**CITY OF ISSAQUAH  
MAJOR DEVELOPMENT REVIEW TEAM  
ISSAQUAH HIGHLANDS and WSDOT TDR PRELIMINARY PLAT  
PARCELS 1 and A  
STAFF REPORT**

**November 29, 2011**

**Project:** Preliminary Plat of  
Issaquah Highlands Parcel A  
WSDOT TDR Parcel 1  
PP11-00001

**Request:** Application for approval of a preliminary plat for Parcels 1 and A of Issaquah Highlands and WSDOT TDR respectively, establishing 80 residential lots, roadways, and 9 tracts for future open space, trails, and utilities on 14.22 acres.

Location of Woonerfs

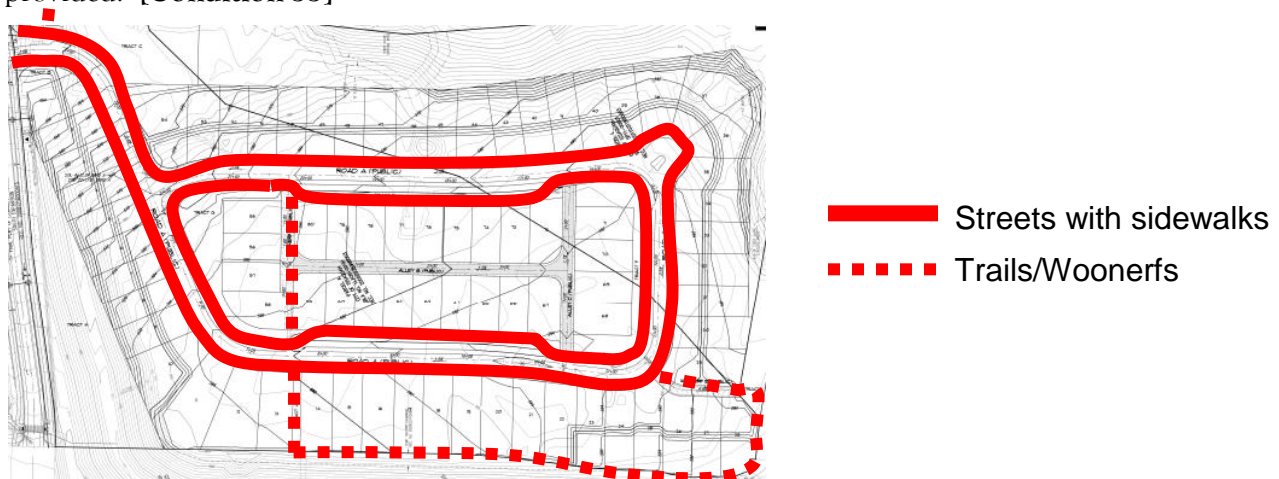
**Woonerf A:** This woonerf is part of the alley network within the internal block proposed in this plat. Normally this would be an alley, but the applicant has proposed this section of alley as a woonerf to break up the block length (see the Section on **Urban Design Guidelines** for further discussion of block size) and provide a more direct connection from the Town Center/High Street stair through the plat to Falls Drive. Though alleys are used by pedestrians they are not designed especially for them as features have not been incorporated that convey pedestrian priority as established for Issaquah Highlands. The woonerf section shown on Sht. P04 is appropriate.

**Woonerf B:** This woonerf is provided as shared access to the homes on Lots 26 through 28 for pedestrians, vehicles, and Eastside Fire and Rescue (EF&R). To ensure EF&R access to the homes on Woonerf B there are certain constraints that must be applied. That is, an access drive which will be used by EF&R is limited to three homes and must have a minimum of 15 ft of paving width. (Note that on Sht. P04, the Woonerf B is shown as being 12 ft wide in a 15 ft tract.) Since Issaquah Highlands impervious surfaces are limited to the minimum paving necessary, no more than 15 ft of width will be used. Woonerf B begins behind the sidewalk, so it must have a driveway cut from Road A and no perceived grade change relative to the sidewalk. Woonerfs don't allow curbs except in certain specific circumstances: to ensure parked cars don't extend past the edge of the paving and if grades won't accommodate an inverted crown for storm drainage. As neither of these situations are present, no curbs may be used, and the woonerf will use an inverted crown; sheetflow is not allowed. **[Condition 33]** Finally, to ensure drivers on woonerfs can see pedestrians, it is necessary to limit landscape and architectural features placed near walkways.

- 33 Woonerf B will be constructed in concrete, 15 ft wide, with no curbs, and serve no more than three homes. It will have a driveway cut from Road A, and all grade change must occur between Road A and the sidewalk, and no perceived grade change shall occur in the sidewalk or between the sidewalk and the woonerf. The woonerf will use an inverted crown; it may not sheetflow into adjacent lots. No parking is allowed within this woonerf. This will be reviewed with Utility Permits.

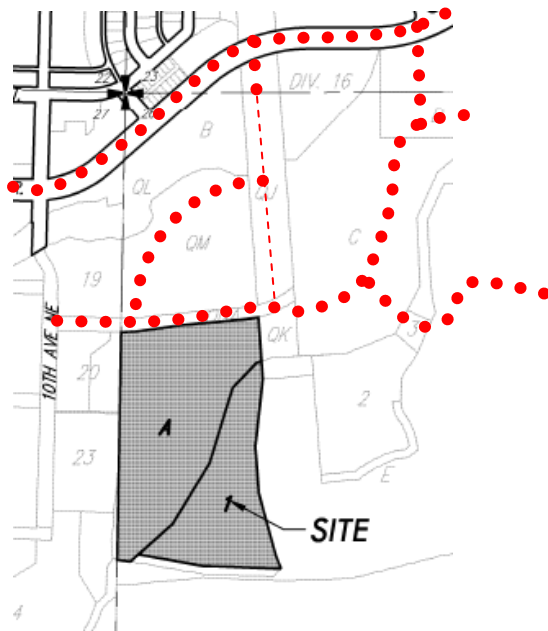
Just after turning off Falls Drive, into the plat, a driveway cut is shown on the east side of Road A, crossing Tract C. This drive is for Williams Gas and PSE to inspect their lines within the easements east of the parcels. Due to the grades of Falls Drive and within Tract D, there is no other access point. However, this point should be designed so that its visual impact is minimized and no other vehicles can access the Williams Gas/PSE easement area, such as the use of bollards. However, pedestrians should be able to use this drive as an access point to the Williams Gas/PSE easement “trail.” (See the Section on **Trails** for discussion of Combined Use Trail.) The Williams

Gas/PSE easement is not an official trail, it has not been and will probably not be improved, and deadends at about the south end of the plat due to a steep dropoff which limits a connection from this “trail” to the Issaquah-Highpoint Trail. However, it is still a pleasant area in which to walk and should be accessible to pedestrians.

Locations where paving will change in association with pedestrian route crossings

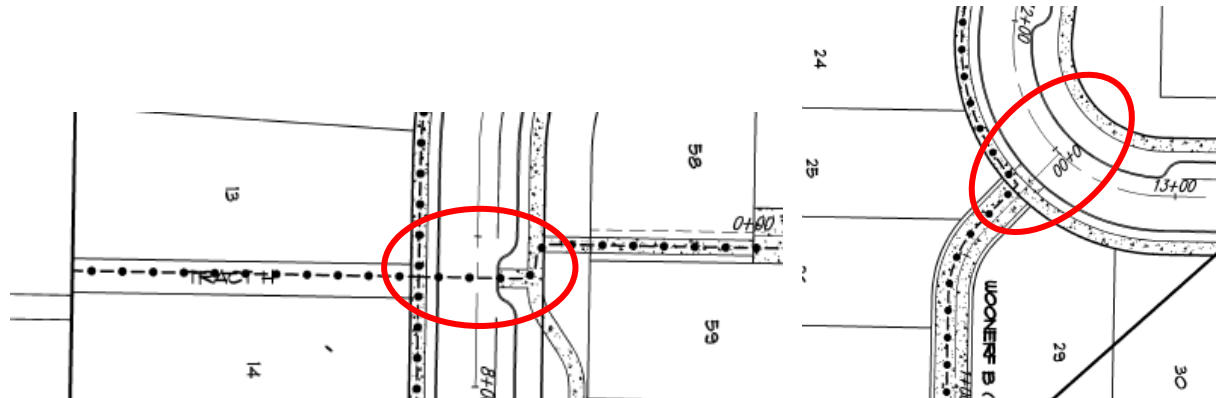
To improve the pedestrian orientation, where pedestrian ways intersect with vehicular routes, including streets and alleys, treatments shall be used which clearly delineate the pedestrian priority and enhance pedestrian safety. This is consistent with the objective: *“Encourage pedestrian priority in circulation by creating paving changes, raised crosswalks, and neighborhood street entry bottlenecks to slow vehicle traffic”* as well as *“Paving patterns changes, varied paving materials and color, and accent paving are used to reinforce the residential character of the neighborhood at high use and important pedestrian locations.”* [Condition 43]

- 43 Designated pedestrian paths and trails which cross vehicular routes, drives, access routes, etc... shall be designed to draw the driver's attention to the possible presence of pedestrians. This condition would be met, for example, through the use of pedestrian tables, changes in material (e.g. concrete, pavers; not solely paint or striping), etc... Emergency vehicle routes shall not use raised crosswalks. This will be reviewed with Utility Permits.
- 44 Replace the road bulb-out serving Lots 35-38 with a pedestrian-oriented solution, such as a shared surface. The appropriate solution will provide pedestrians with a direct route from Lot 35 to 38, give pedestrians priority over cars, while maintaining access to residents and EF&R. EF&R must be able to get within 150 ft of the furthest point of each home (as the hose lays). This will be reviewed with Utility Permits.

Left: original proposal.:

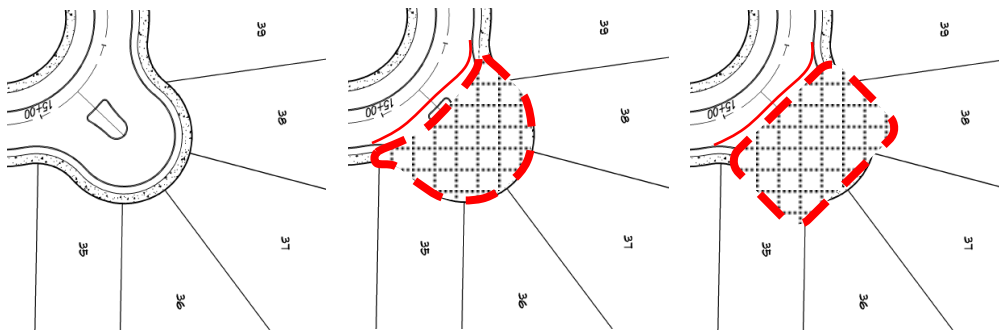
The other location that needs further pedestrian circulation refinement is the sidewalk at Lots 35 through 38. To provide vehicular access to the lots, a road bulb-out is shown. This improves vehicular access while making the pedestrian route significantly longer and less direct. As pedestrians are given priority, the design must facilitate pedestrian movements over vehicular, while accommodating automobile as well as EF&R access. Also EF&R must be able to get within 150 ft of the farthest point of a house on any of these lots (as the hose lays). A solution would be to continue the curb line as if the street turned there, and using a driveway cut, create a shared surface, such as a woonerf, behind the curb. This will be a low vehicular volume area which will be appropriate for a pedestrian-oriented, shared-surface solution such as a woonerf. [Condition 44]

Location of lots with narrow street frontage

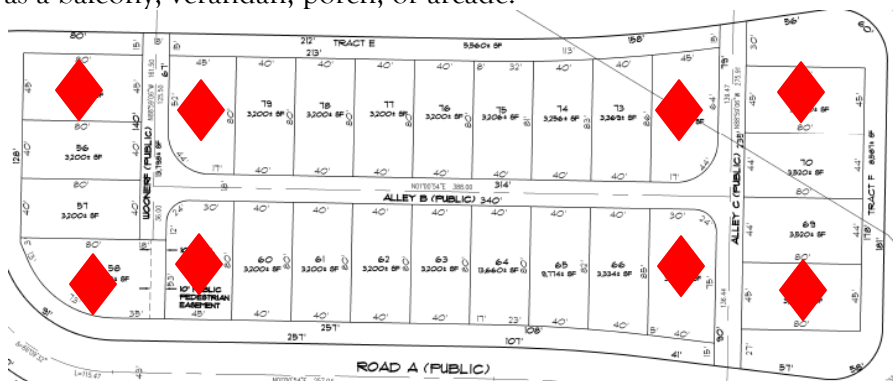
The plat has corner lots which are important opportunities to create unique homes that finish the block and provide attractive view termini. Corner lots need to be a bit more generous than interior lots to accommodate porches and other elements that turn the corner of the building and finish its exposed side. The design of plat provides for more generous corner lots (about 5 ft wider), consistent with many goals and guidelines:

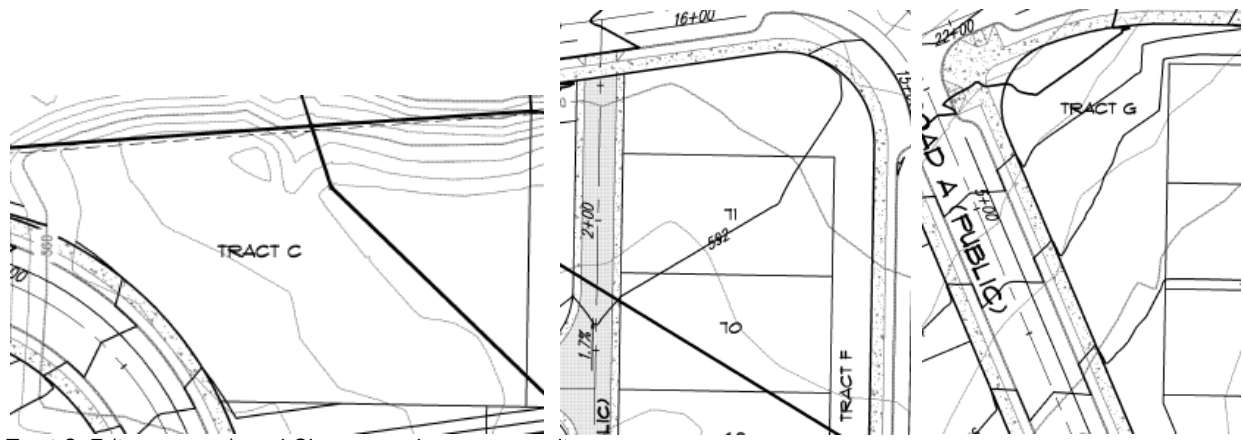
The primary shared open spaces are Tracts C, E, F, G. Tracts C and G are, in particular, geared to provide gathering and recreation space. Tract F provides two moderate sized spaces at the south end of the plat. Specific review of the proposals will occur with the ASDPs for these tracts. No information was provided on the uses other than the Narrative which described Tract C as "landscaped open space containing a level lawn area for active recreation" and Tract G as "landscaped open space with a tot-lot recreation element." Based on the following excerpts from the Development Agreement, the tracts should be designed to more carefully incorporate children's play as well as provide meaningful uses of shared land within the plat.

A more child-sensitive approach, consistent with the House and Garden Neighborhood Type character would be to incorporate opportunities for play into all tracts without making open space exclusively for small children’s play through the use of big toys. This could include boulders, paths, stepping stones, berms and hills, dry or wet stream, slides, edible plants. This allows more diverse and adventurous play, consistent with the neighborhood type’s character while not precluding other residents from visually and physically enjoying the area. **[Condition 46]**

As Tracts C and G are the only real open space for recreation, they should provide relatively flat areas of reasonable size to accommodate play. Tract C already appears fairly flat and those grades should be maintained as construction documents are prepared. Tract G is currently proposed to have a moderately sloped site. The appropriate grades will be determined based on the equipment and activities in Tract G, which will be reviewed with the ASDP for the Tract. Development of all the open space tracts provides an excellent opportunity to offer the diversity of spaces discussed in the Development Agreement. No uses are described for Tract F’s two spaces, but they provide great small scale opportunities to introduce diversity within the plat. **[Condition 47]**

- 47 Open space tracts should provide a diversity of passive and active recreation for all ages. Tract C shall maximize level space, defined as 2-3% maximum cross slope. Grading in Tract G shall complement the tract's activities and to make them more interesting for users and adjacent uses. Tract F should provide unique and complimentary uses for the two corners sites created by the plat. This will be reviewed with the ASDPs for these tracts as well as Utility Permits.

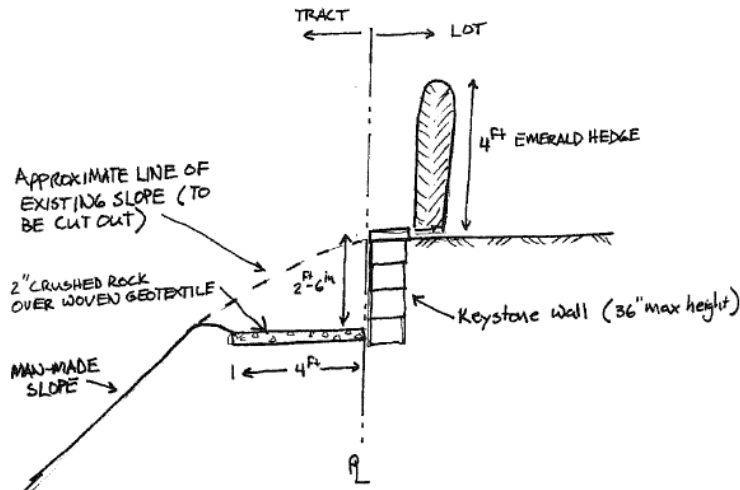
To maximize the use of the open space tracts, facilities such as walkways and significant plant materials that serve pedestrians and recreation as well as achieving the House and Garden character, must take precedence over underground utilities, vaults, above ground utility equipment, etc.... Access and equipment associated with wet and dry utilities are a necessary part of a functioning community. However, their presence does not enhance the overall project character and objectives. Screening and location can reduce the impact of these necessary elements. **[Condition 49]**

- 49 In parks and landscape tracts, design of the above ground facilities, such as walkways, significant plant materials, etc... shall take priority over the convenient location of utilities, unless this would significantly compromise the function of the utilities. Place above ground utilities in inconspicuous locations and screen them. On construction permits, utilities and their necessary easements shall be shown. This will be reviewed with the Administrative Site Development Permit(s) for these tracts as well as Utility Permits.

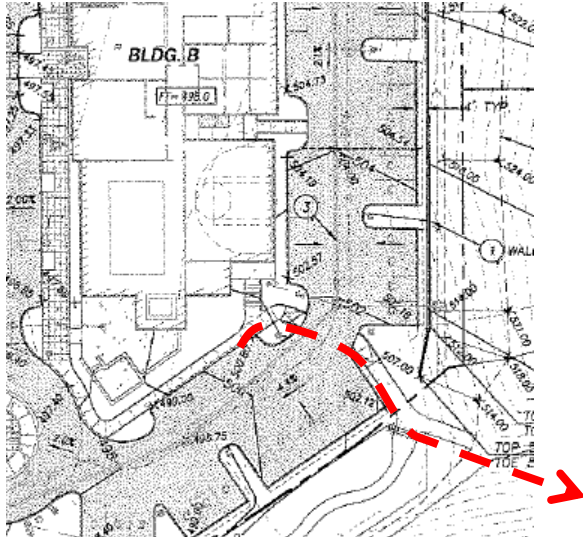
**Neighborhood Trail:** Tract H will contain a Neighborhood Trail connecting Road A to the stairs in Tract QI, ending at 10<sup>th</sup> Ave in East 42/Town Center/High Streets retail. Tract H is 11 feet wide though the Neighborhood Trail standard is a 6 ft trail with 4 ft landscape borders, for a total of 14 ft. The applicant is proposing a 5 ft trail with 3 ft borders, which would require an AMM. A tread 5 ft wide is consistent with the City's sidewalk standard. The borders are present to ensure sufficient landscape is provided on either side of the trail and a gauntlet effect is not created. If the fences or landscape on the adjacent properties is restricted to 42 inches, then 3 ft borders may be sufficient. The submittal does not appear to indicate the surface of the trail but it should be consistent with the Neighborhood character which indicates concrete or special paving. **[Condition 53]** The access for Lots 55-57, and possibly 58, will also be a Neighborhood Walk, providing access to these homes between the lots and the tot-lot anticipated in adjacent Tract G. The trail serving these lots may be just 5 ft wide, like a sidewalk. In some but not all instances, it appears that the space for borders, as required by the trail standard, is available. The future designs must comply with the adopted standard, except for the tread width. In addition, trails standing in for sidewalks, i.e. providing pedestrian access to the front doors of homes facing Tract G, must be constructed like sidewalks: concrete, direct, etc.... **[Condition 54]**

- 54 All exterior staircases and paths shall be at least 5 feet wide, clear of intruding handrails, mature landscape, car overhangs, light poles, tables and chairs, etc.... There shall be no single steps in each stair and they shall be generally level. Planter beds adjacent to walkways, shall select plants whose mature size will not impact the walkway width. Sidewalks, trails, and paths 15% or greater shall use stairs to negotiate the grade. This will be reviewed with Utility and/or Building Permits.
